SERVICE 		3
		X 89.122-26

MODEL: **50 SPECIAL**

FLYWHEEL, CRANKSHAFT

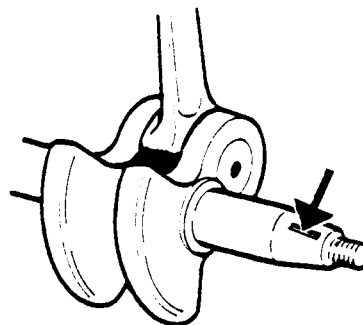
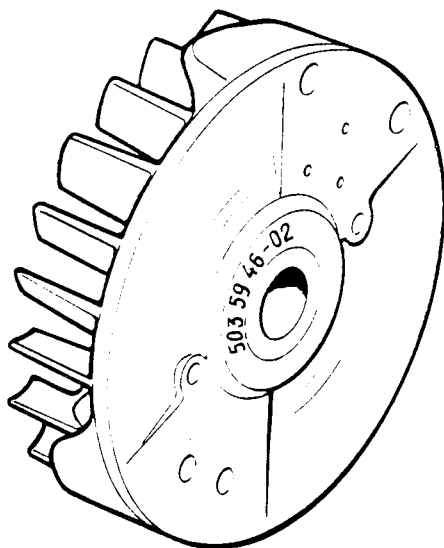
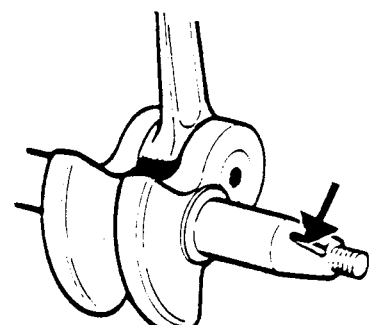
We have introduced a new flywheel and a new crankshaft in order to facilitate repairs and to secure a correct assembly.

This means that the conventional location of a key in a keyway of the crankshaft has been replaced by a cast-in key in the flywheel. This results in a change of the keyway in the crankshaft. (See ill.)

It is not possible to assemble a new flywheel on an older crankshaft and an old flywheel on a new crankshaft.

The new flywheel can only be fitted on the new crankshaft and a separate key cannot be fitted in the keyway of the new crankshaft.

The change is introduced from serial No. 9250856.
